1 Redline Revision Dated September 20, 2012

MD 198 (FORT MEADE RD) AND MD 197 (LAUREL-BOWIE RD)/IRVING ST

TRAFFIC SIGNAL PLAN

TS NO. 1847K | DRAWING NO. 1 OF 4 | SHEET NO. OF

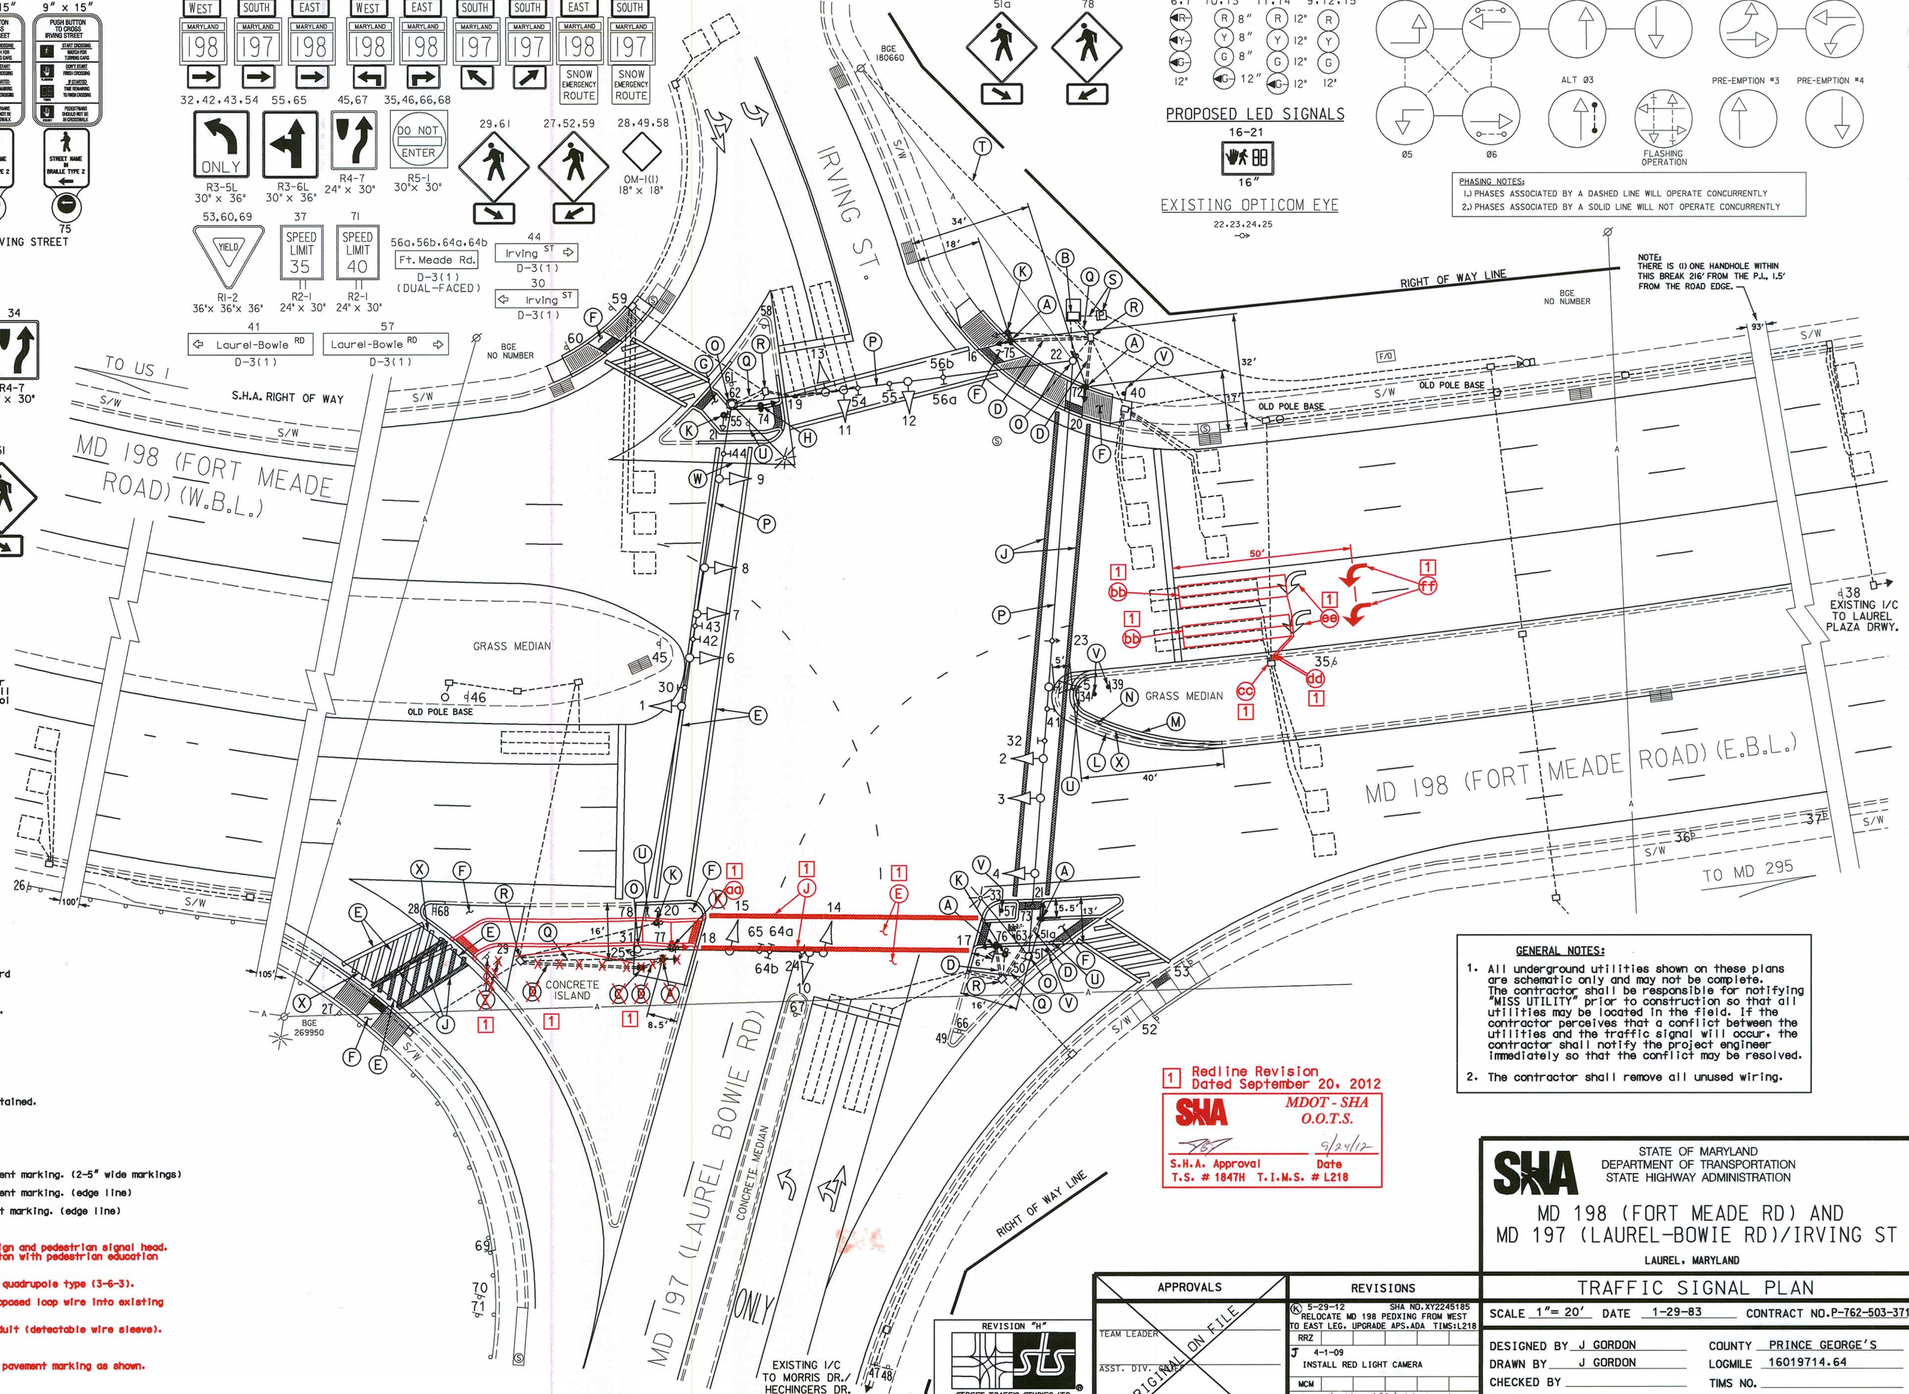
1 C. ~~Install~~ handhole.

1 Z. ~~Relocate~~ existing ground mounted sign as shown.

1 aa. Use existing pedestal pole. Remove existing pushbutton and sign and pedestrian signal head. Install Countdown pedestrian signal head and audible pushbutton with pedestrian education sign using existing wiring.

1 bb. Install 6'x 30' loop detector encased in 1/4" flexible tubing quadrupole type (3-6-3).

1 cc. Disconnect existing presence loops in handhole and splice proposed loop wire into existing 2-conductor shielded cable.

1 dd. Install 1" liquid tight flexible non-metallic electrical conduit (detectable wire sleeve).

1 ee. Remove existing left turn arrow pavement marking.

1 ff. Install left turn arrow heat applied perforated thermoplastic pavement marking as shown.
